**BROWNS FERRY NUCLEAR PLANT (BFN) - UNIT 1 - TECHNICAL
SPECIFICATIONS (TS) CHANGE 434 - RESPONSE TO REQUEST FOR
ADDITIONAL INFORMATION REGARDING LOWERING THE ALLOWABLE VALUE
FOR REACTOR VESSEL WATER LEVEL - LOW LEVEL 3**

**TENNESSEE VALLEY AUTHORITY
BROWNS FERRY NUCLEAR PLANT, UNIT 1
RESPONSE TO REQUEST FOR ADDITIONAL INFORMATION
PROPOSED TECHNICAL SPECIFICATION CHANGE 434
ALLOWABLE VALUE FOR REACTOR VESSEL WATER LEVEL SETPOINTS**

REACTOR VESSEL WATER LEVEL SETPOINTS

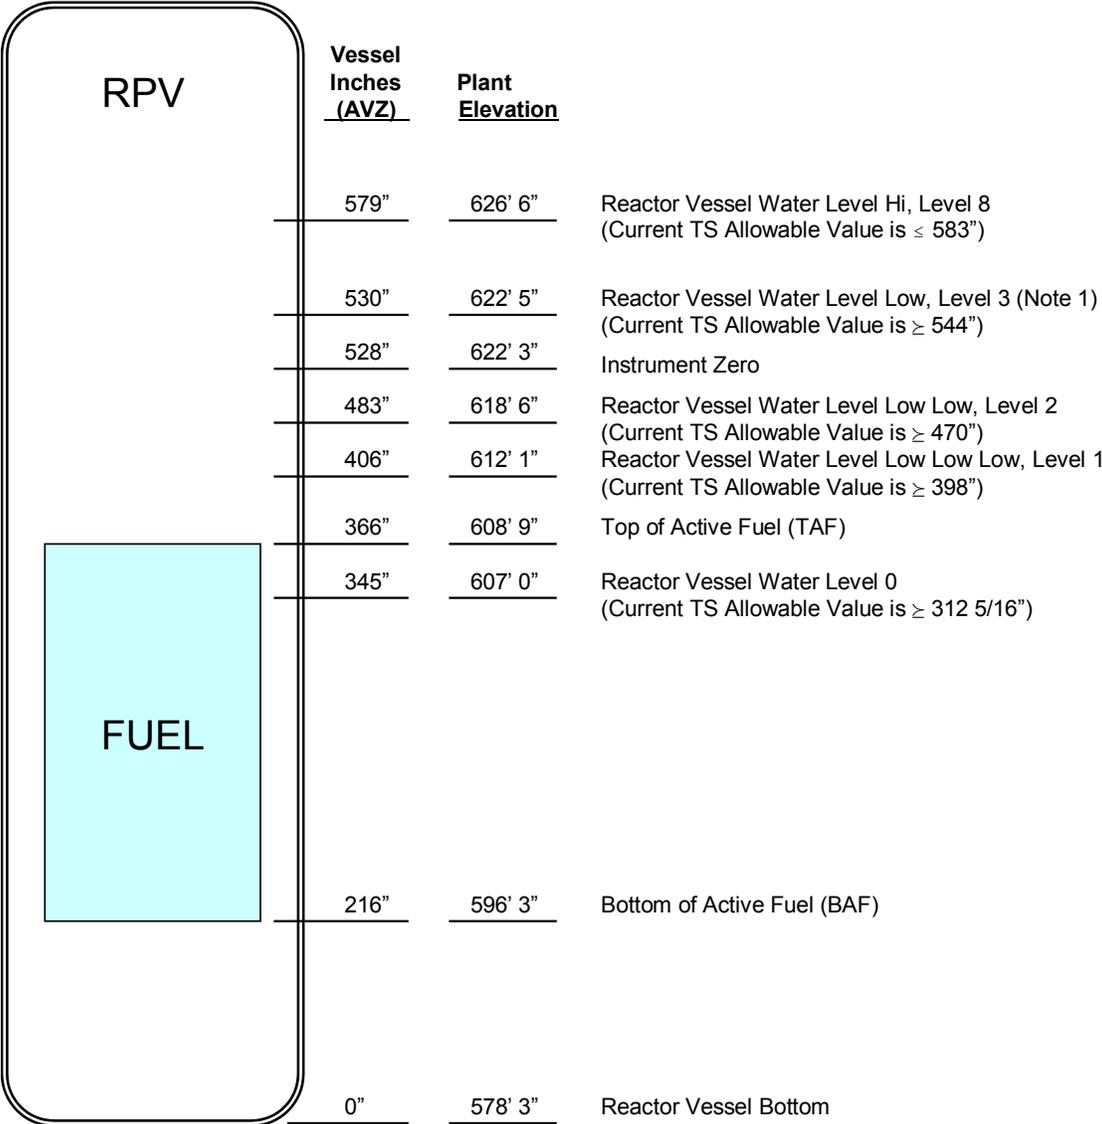
4. Please provide a simplified figure that shows, as a minimum, the elevations of the water in the reactor vessel for Level 3 and the top of active fuel.

A copy of the simplified figure is attached.

1. Proposed setpoint based on submitted Technical Specification Change Request TS 434.
